**RE : Responses to City of Mississauga Comments, Noise Feasibility Study, Proposed Residential Development, 1489 Hurontario Street, Mississauga, Ontario
HGC Project #: 02100120**

Figure 3 – Proposed Site Plan Showing Barrier and Ventilation Requirements

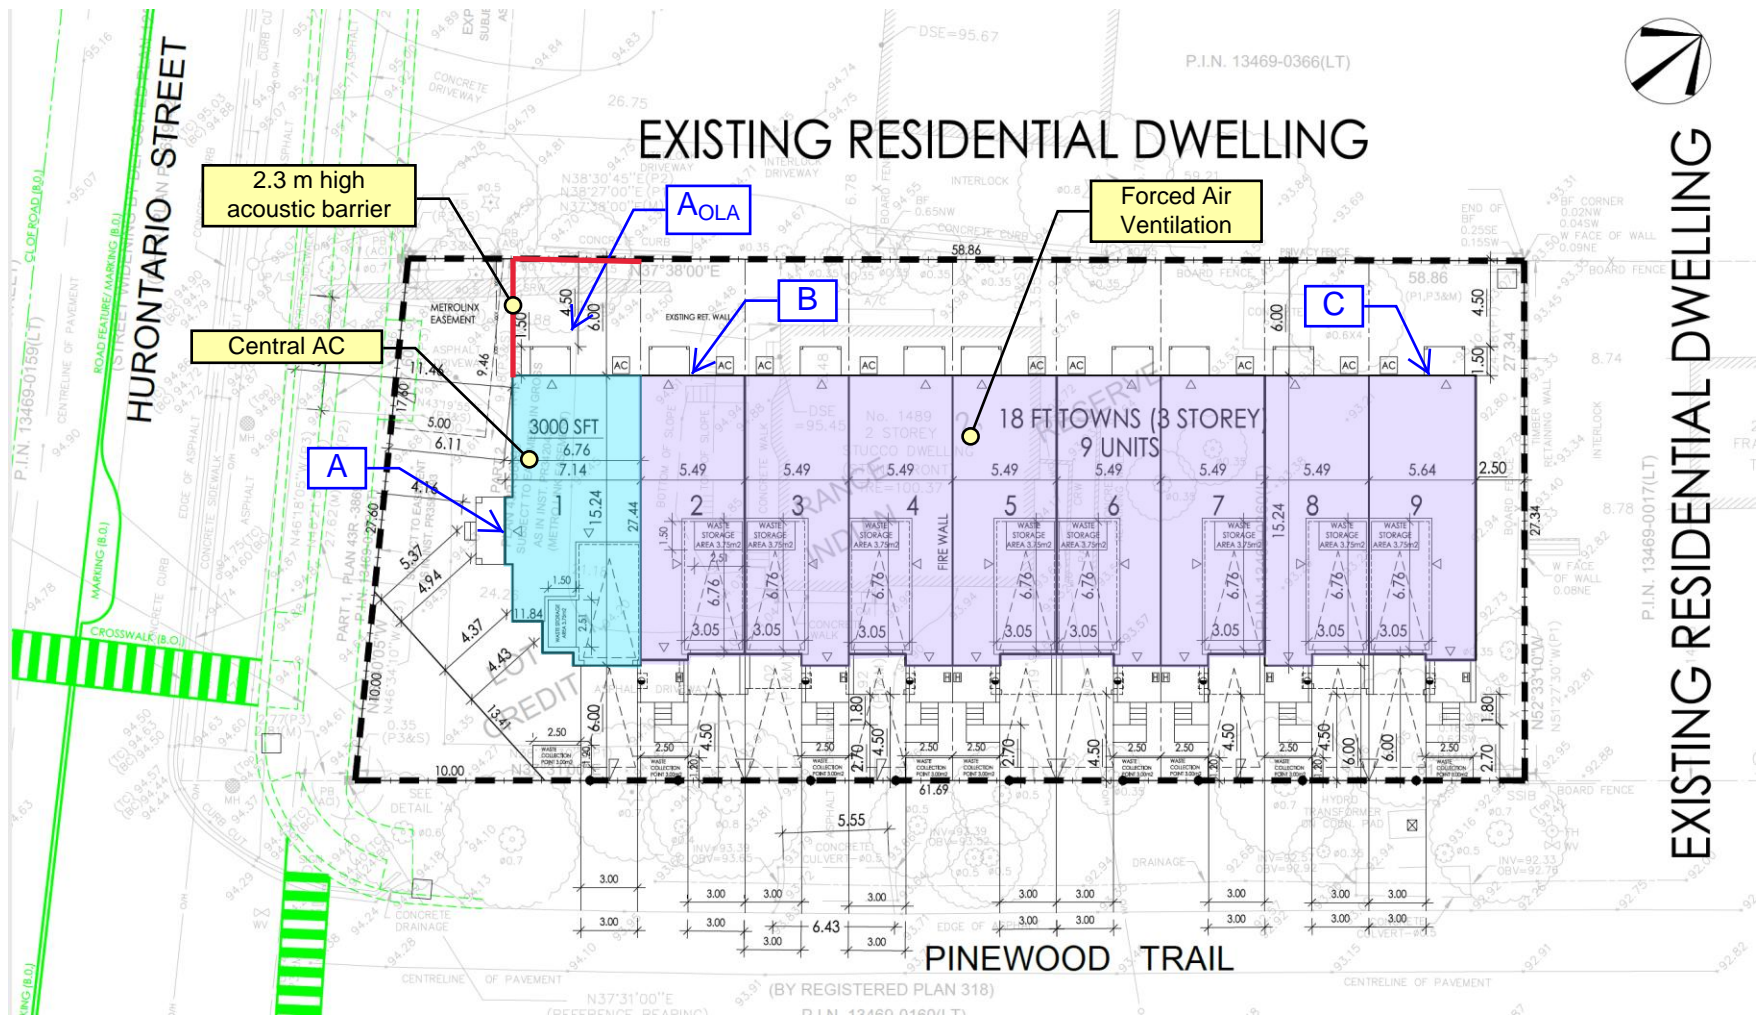
- The report recommends a height of 2.4m for the acoustic fence on Lot 1. Ensure the report and plans are updated to show/label the fence and height.

An updated site plan, dated February 19, 2025, has been provided. The analysis has been updated to reflect the new site plan and indicates that a 2.3 m acoustic barrier will reduce the sound level to 57 dBA and is recommended. The figure has been updated to reflect the recommended height of 2.3 m and is attached.
